**Office of
Environment
& Heritage**

RE: Tahmoor South Coal Project - EIS Exhibition (SSD 8845)

OEH DETAILED COMMENTS ON TAHMOOR SOUTH COAL PROJECT – EIS EXHIBITION (SSD 8445)

Figure 1: Koala Corridors in the region surrounding Tahmoor South

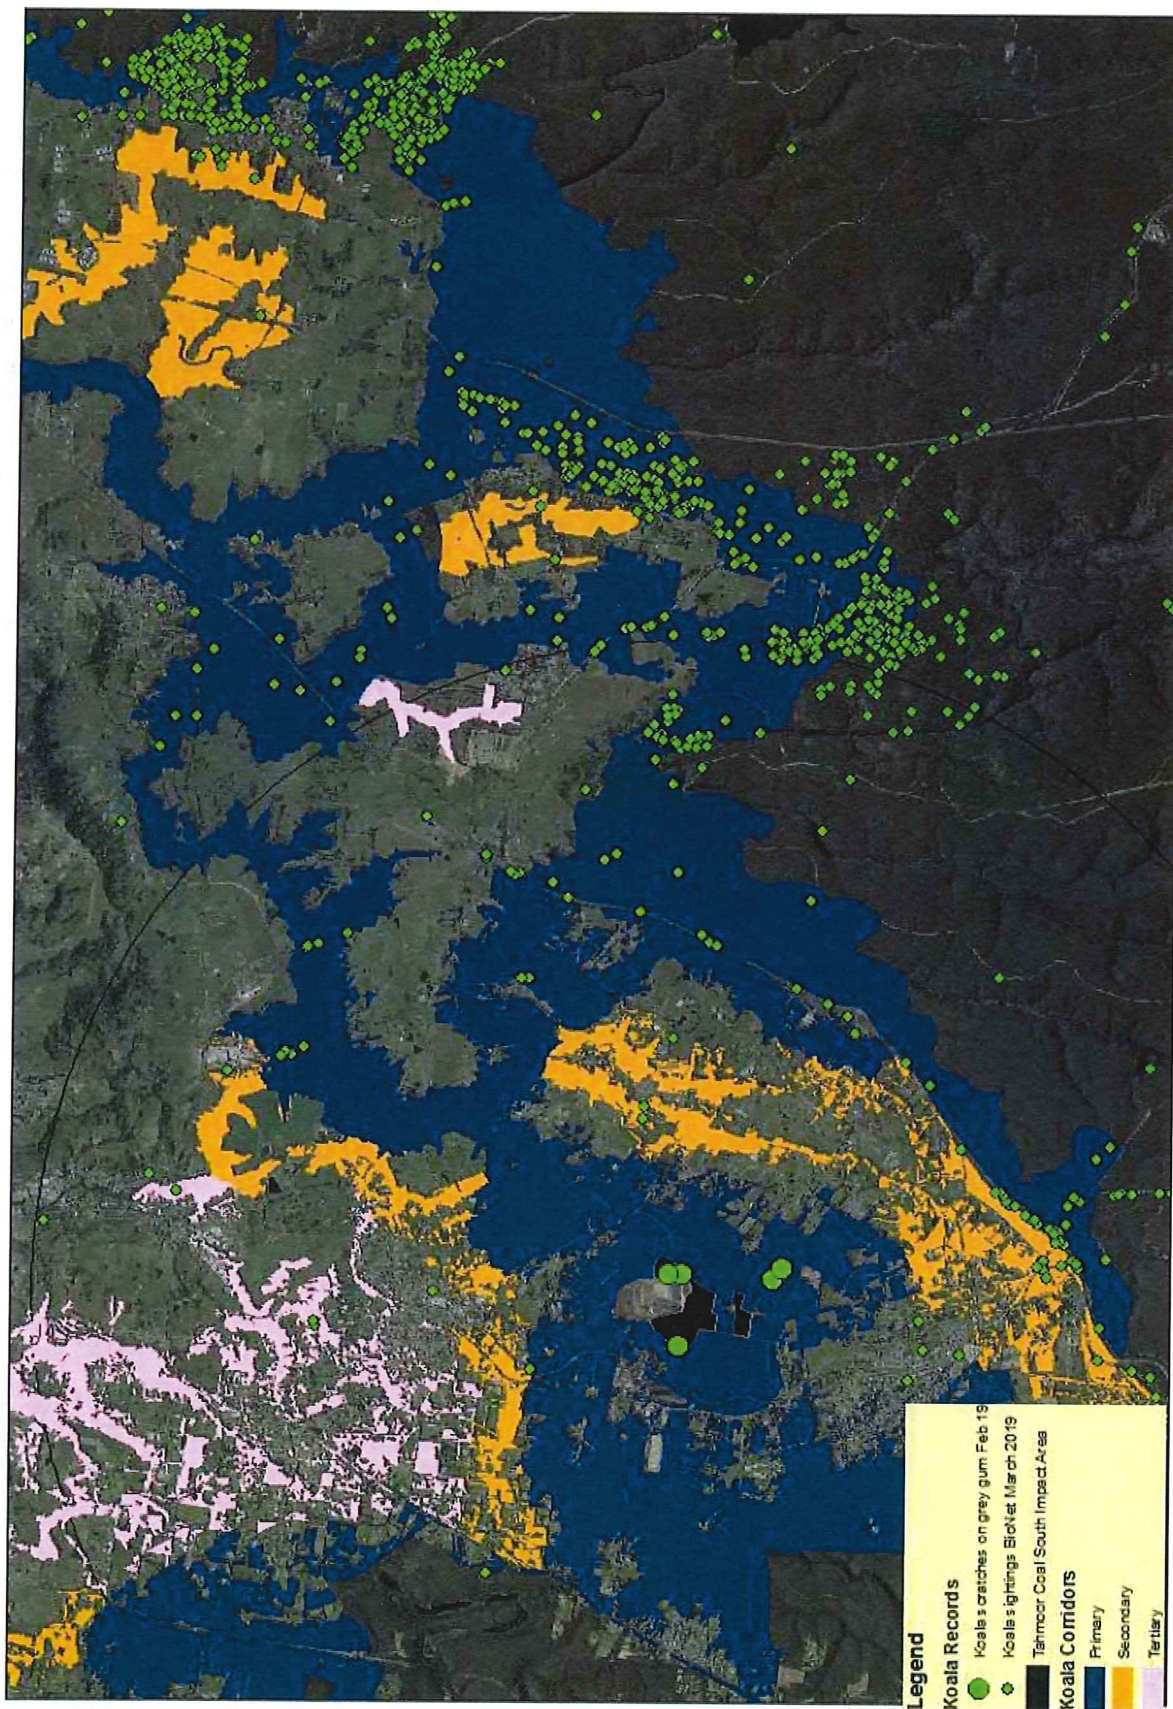
In addition to the removal of high-quality habitat, the proposal will impact on a primary movement corridor for the koala (see Figure 1; OEH 2019). All 49.1 ha of koala habitat is within a major regional koala link. The locality is also at the nexus of three primary koala linkages, the Bargo Corridor, Tree Hollow Corridor and Dog Trap Corridor, as mapped by OEH. These corridors are critical north-south and east-west links for the expanding koala population of south-west Sydney. The vegetation communities proposed for removal are higher fertility woodlands which are considered the most important vegetation types in the region for koalas.
